Cranberry Meadow Farm

East Haddam, Connecticut
January 1987

ENVIRONMENTAL REVIEW TEAM REPORT

Review Date: NOVEMBER 17, 1986

BEDROCK GEOLOGY

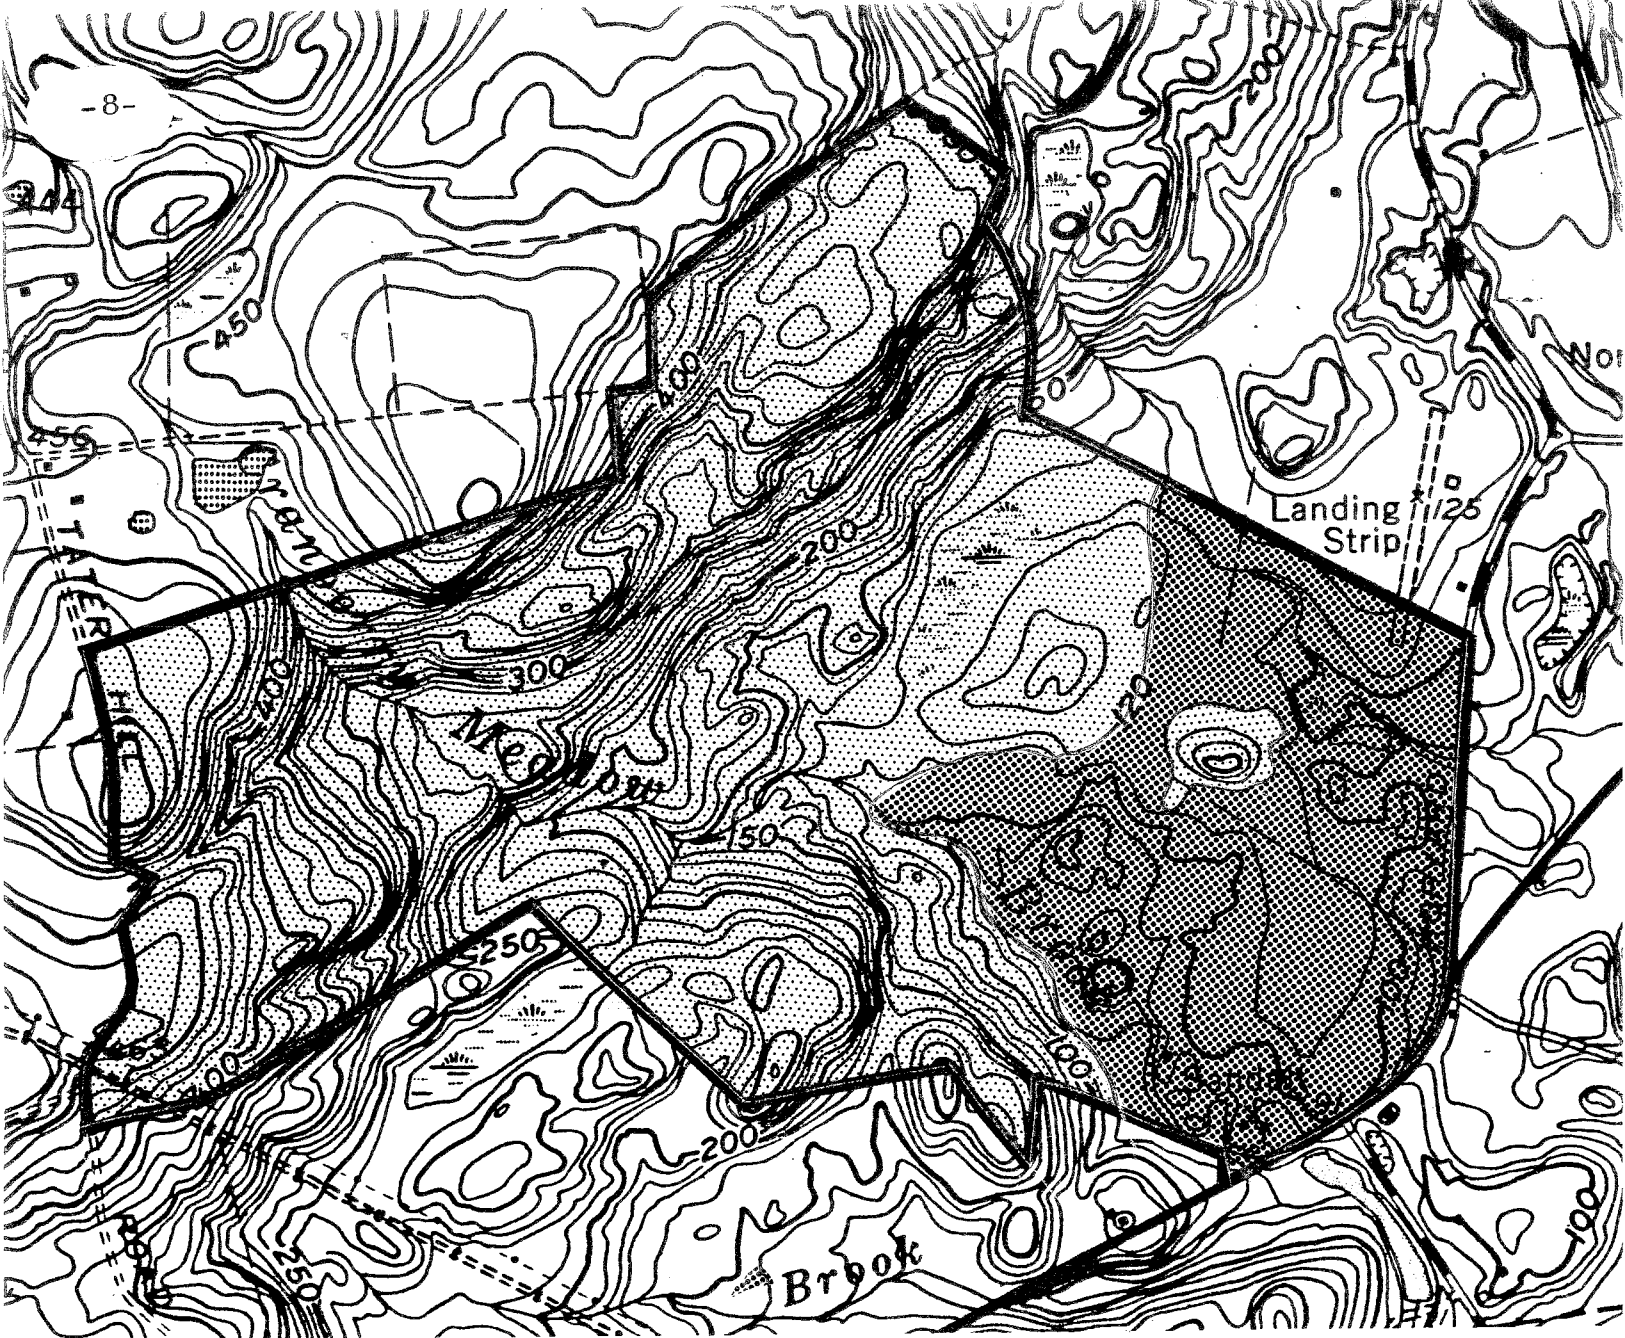
A major geologic boundary, known as Honey Hill Fault traverses the central parts of the site. It separates rock types, which differ in age, texture and mineralogy. Rock types to the north of the fault, consist mainly of gneisses and schists, while rock types to the south are mainly rocks of granitic (rich in quartz and feldspar) composition. (See attached Bedrock Geologic Map for detailed descriptions).

A +1/2 mile wide zone of thinly layered or laminated rock, which resulted from the faulting activity, parallels the route of the Honey Hill Fault. The geologic term given to these type of rocks are "mylonites". The thinly-layered structure of the mylonites makes them excellent stones for stonewalls. Most of the stones comprising stonewalls on the site are "mylonites". It should be pointed out that the Honey Hill Fault is an inactive fault. The foliation/or/layering in the rock throughout most of the site dips gently to the northwest.
